This bulletin replaces bulletin 98-2.

4.3L, 5.0L and 5.7L Replacement Parts

Non Gen+ Replacement 4.3L and 5.7L Piston Ring Sets

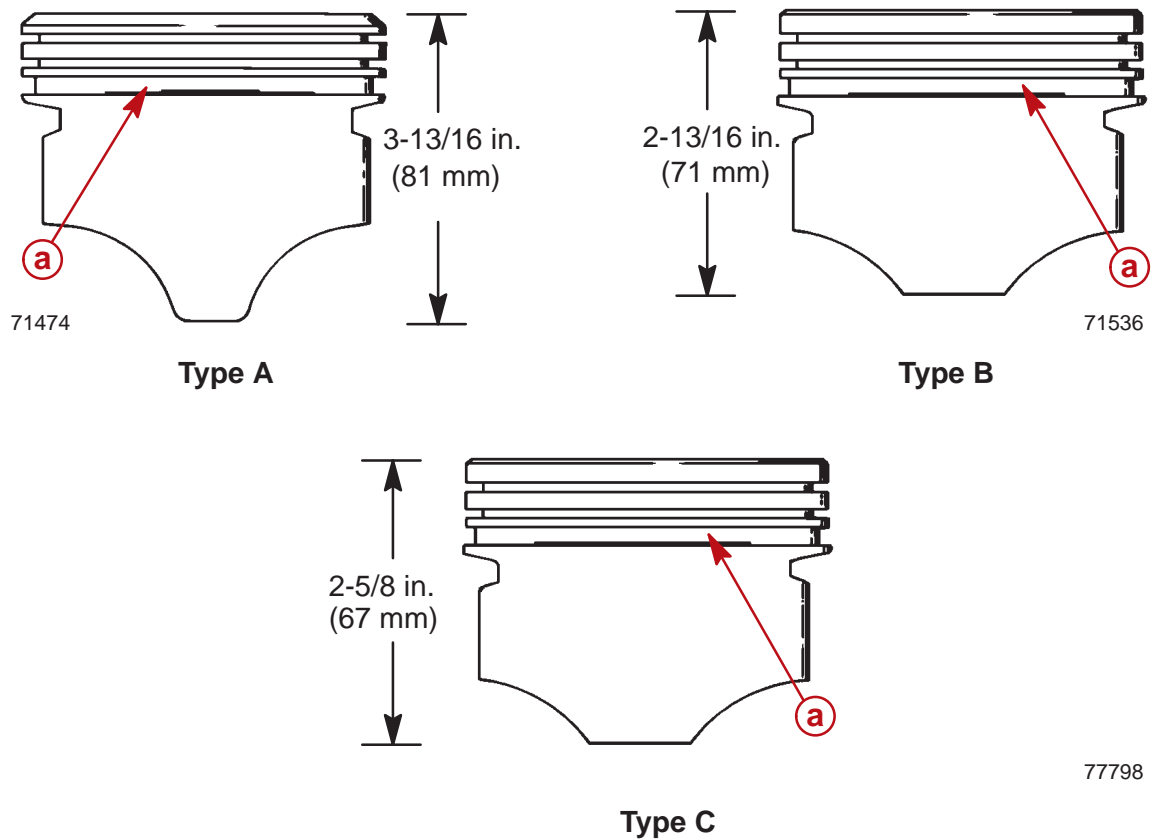
Before ordering piston ring sets, check the type of piston that the ring set will be used on. Pistons have different top and second ring groove widths and different oil control ring groove depths. Gen+ pistons were used in late production non-Gen+ engines. Measure oil ring groove depth in piston and the width of the top and second rings before ordering.

a - Oil Control Ring Groove

Piston Type	Order Ring Set
<p>Type 'A'</p> <p>Piston height: 3-3/16 in. (81 mm). Top and second ring width: .077 (1.955 mm). GM piston with deep oil control ring groove depth: .190 in. (4.826 mm) or .220 in. (5.588 mm). OR Quicksilver pistons with deep oil control ring groove.</p>	<p>P/N 39-17464 for Standard OR P/N 39-17465 for .030 in. Oversize</p>
<p>Type 'B'</p> <p>Piston height: 2-13/16 in. (71 mm). Top and second ring width: .077 (1.955 mm). GM piston with shallow oil control ring groove depth: .167 in. (4.241 mm).</p>	<p>P/N 39-801861 for Standard OR P/N 39-803027T for .030 in. Over-size</p>
<p>Type 'C'</p> <p>Piston height: 2-5/8 in. (67 mm). Top and second ring width: .058 (1.473 mm). Gen+ GM piston with shallow oil control ring groove depth: .168 in. (4.267 mm).</p>	<p>P/N 39-801861T 1 for Standard OR P/N 39-835000 for (0.5 mm) Over-size</p>
